ADDENDUM

NO. 4

PROJECT NAME: New Randall Hill Support Center

ADDENDUM DATE: June 23, 2020

FLOOR PLAN - SECTION 1 -
PLUMBING

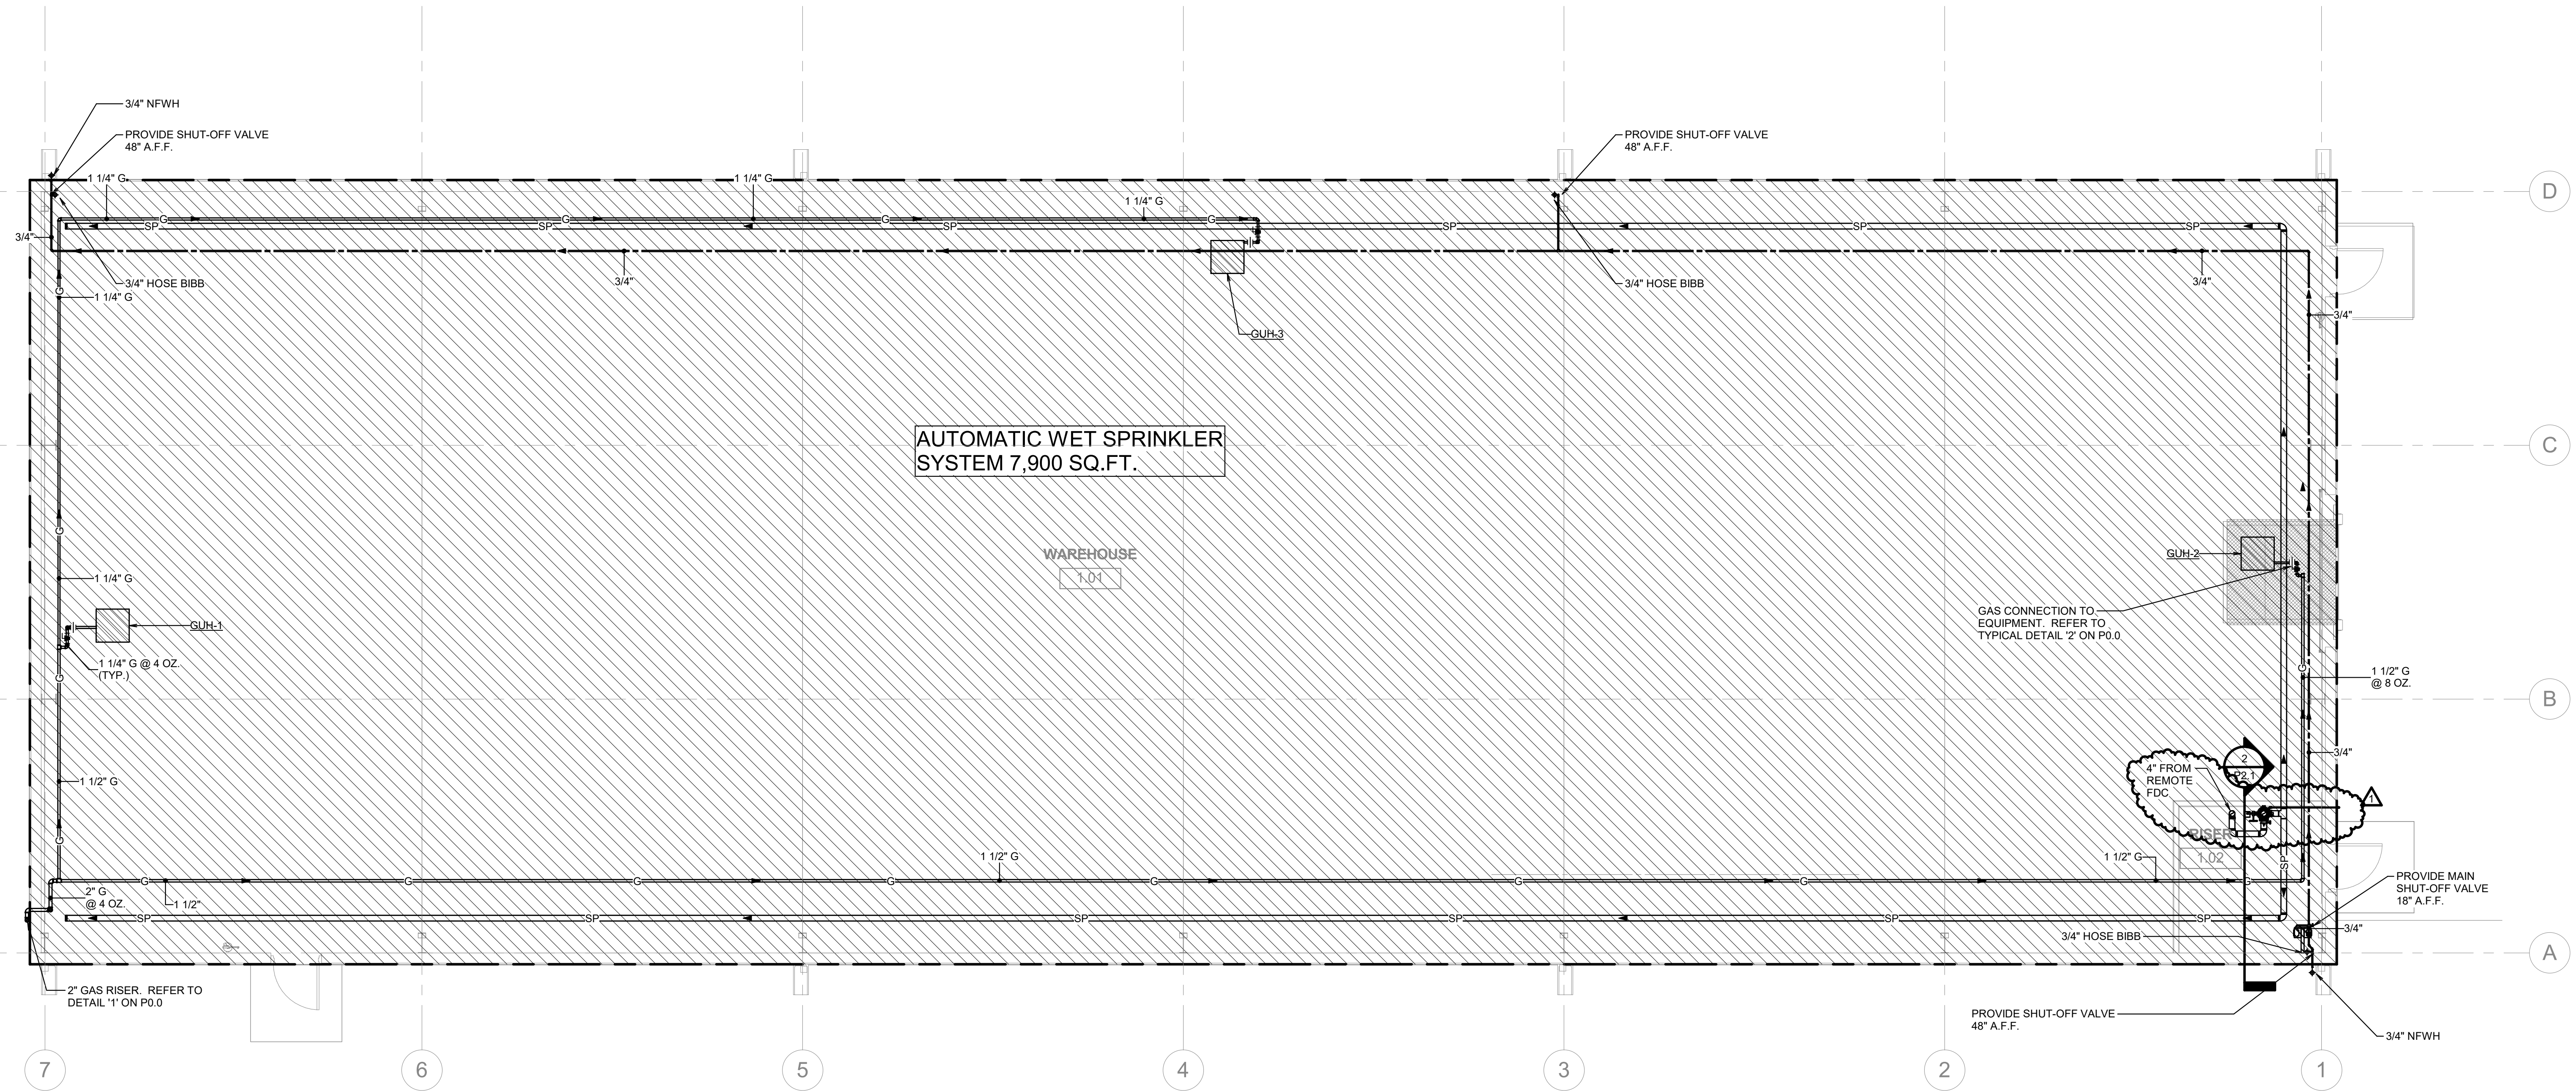
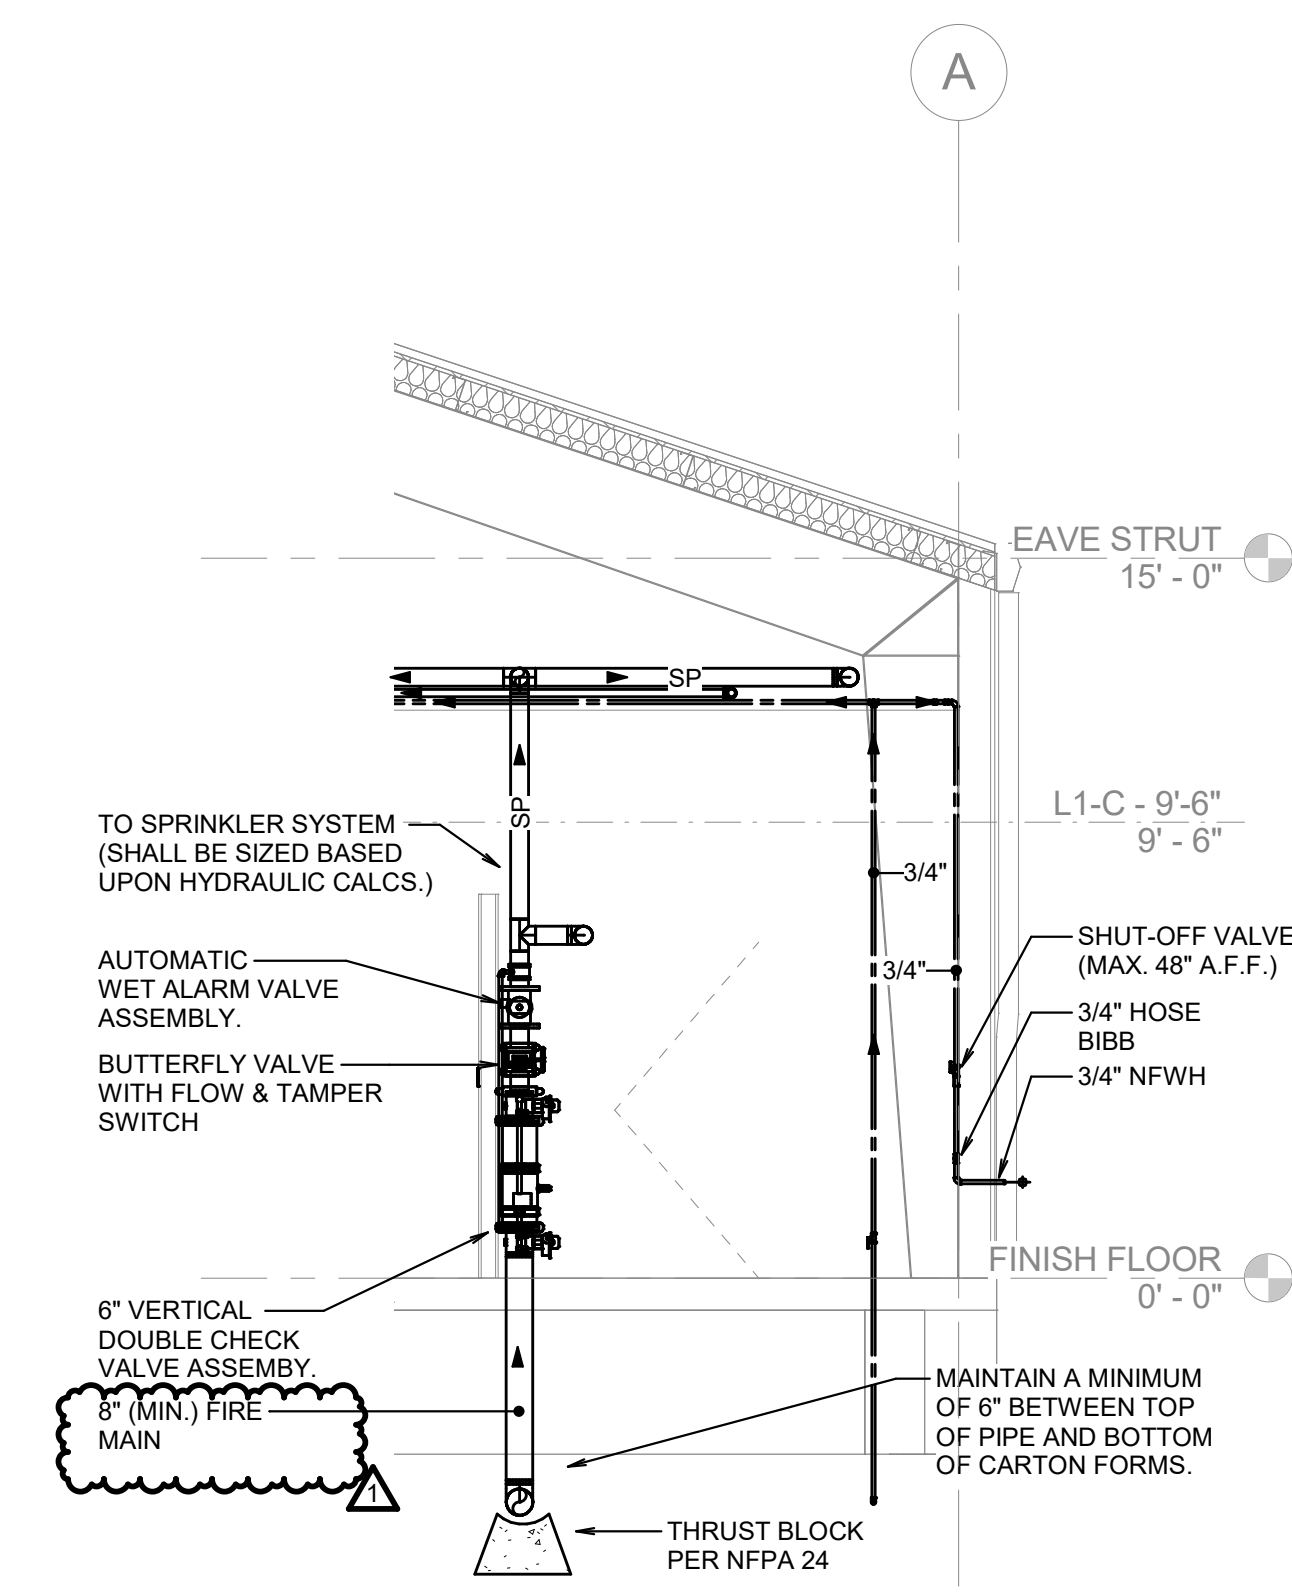
AD No 4, Plb. Item 3: To the Drawings, Sheet P2.1, "FLOOR PLAN – SECTION 1 - PLUMBING"

- 1) Revised Fire Department Connection to on site remote connection per City of Midlothian.
